UNITED STATES PATENT AND TRADEMARK OFFICE

APPLICATION NO.	FILING DATE	FIRST NAMED INVENTOR	ATTORNEY DOCKET NO.	CONFIRMATION NO.
09/929,488	08/15/2001	Kimikazu Matsumoto	250901/00	1362

Office Action Summary

DETAILED ACTION

FIG. 1A(PRIOR ART)

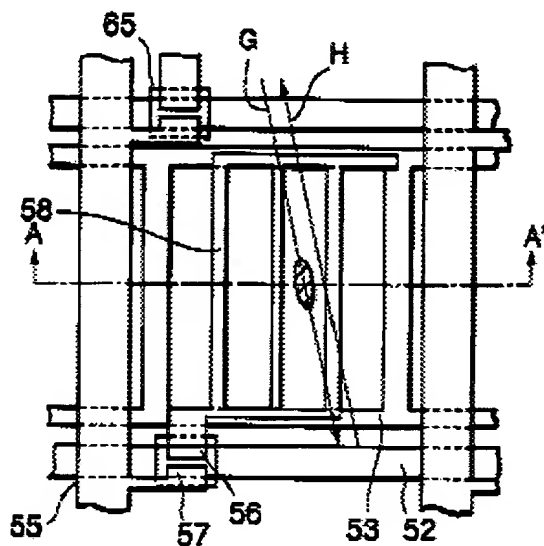
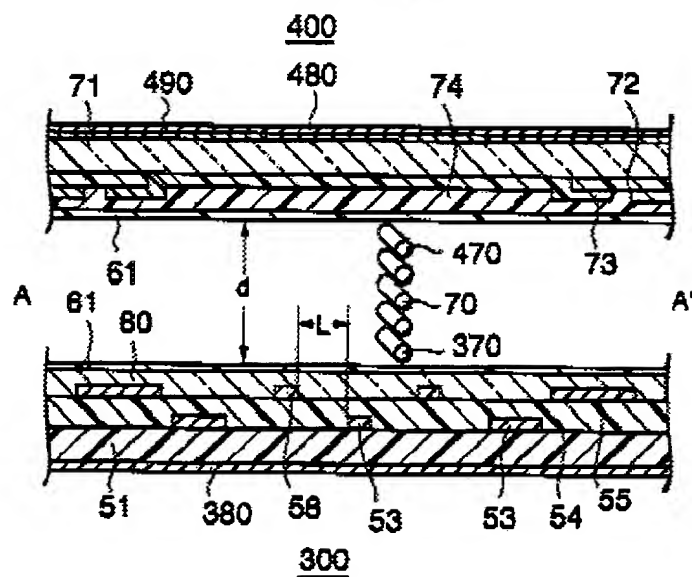
As to claims 8 and 9, Baur does not explicitly disclose a display wherein a gate wiring of a thin film transistor is formed on said first substrate simultaneously with said common wiring and wherein an island disposed above said common wiring and made of a semiconductor film is formed in said insulating film, and said island constitutes an active region of a thin film transistor. However, these are merely common knowledge means of comprising a satisfactory TFT display configuration.

Applicant's admitted prior art (APA) discloses these claimed features in Applicant's Figures 1A and 1B to comprise a satisfactory TFT display configuration.

APA is evidence that ordinary workers in the art of liquid crystals would find the reason, suggestion, or motivation to add a display wherein a gate wiring of a thin film transistor is formed on said first substrate simultaneously with said common wiring and wherein an island disposed above said common wiring and made of a semiconductor

film is formed in said insulating film, and said island constitutes an active region of a thin film transistor to comprise a satisfactory TFT display configuration.

Therefore, it would have been obvious to one having ordinary skill in the art of liquid crystals at the time the invention was made to modify the LCD of Baur with a display wherein a gate wiring of a thin film transistor is formed on said first substrate simultaneously with said common wiring and wherein an island disposed above said common wiring and made of a semiconductor film is formed in said insulating film, and said island constitutes an active region of a thin film transistor of APA to comprise a satisfactory TFT display configuration.

FIG.2

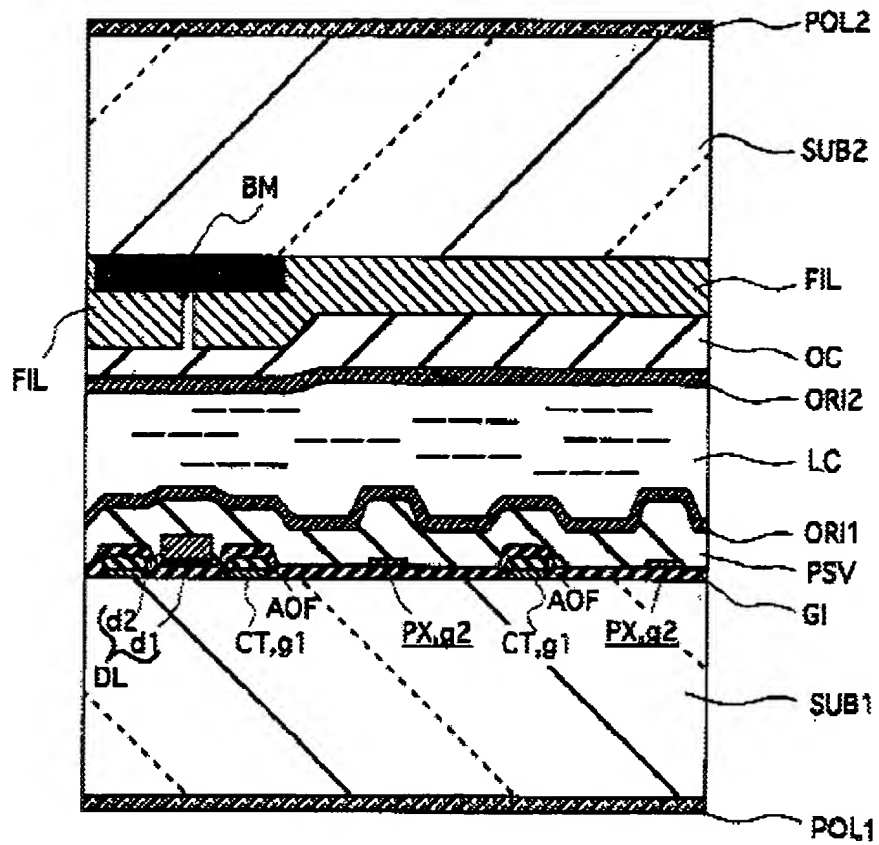
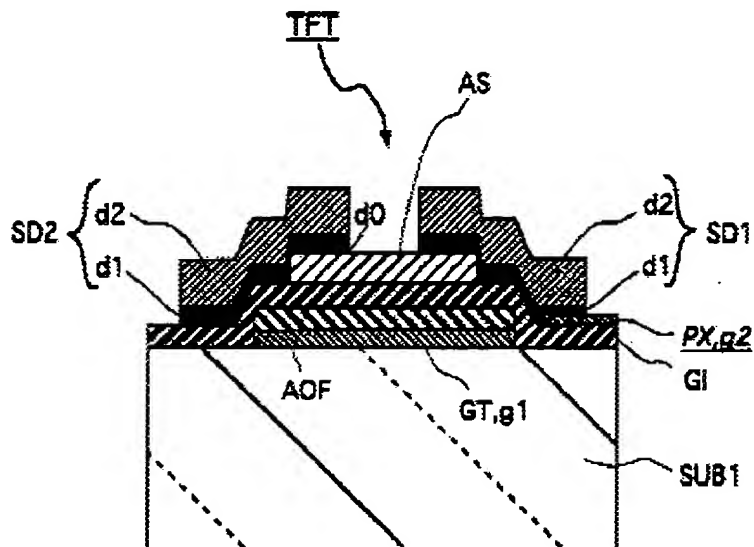
As to claims 8 and 9, Baur does not explicitly disclose a display wherein a gate wiring of a thin film transistor is formed on said first substrate simultaneously with said common wiring and wherein an island disposed above said common wiring and made of a semiconductor film is formed in said insulating film, and said island constitutes an active region of a thin film transistor. However, these are merely common knowledge means of comprising a satisfactory TFT display configuration.

Ohta discloses these claimed features in Figures 2 and 3 to comprise a satisfactory TFT display configuration with *inter alia* wide viewing angle (Abstract).

Ohta is evidence that ordinary workers in the art of liquid crystals would find the reason, suggestion, or motivation to add a display wherein a gate wiring of a thin film transistor is formed on said first substrate simultaneously with said common wiring and wherein an island disposed above said common wiring and made of a semiconductor film is formed in said insulating film, and said island constitutes an active region of a thin film transistor to comprise a satisfactory TFT display configuration with wide viewing angle.

Therefore, it would have been obvious to one having ordinary skill in the art of liquid crystals at the time the invention was made to modify the LCD of Baur with a display wherein a gate wiring of a thin film transistor is formed on said first substrate simultaneously with said common wiring and wherein an island disposed above said common wiring and made of a semiconductor film is formed in said insulating film, and

said island constitutes an active region of a thin film transistor of Ohta to comprise a satisfactory TFT display configuration with wide viewing angle.
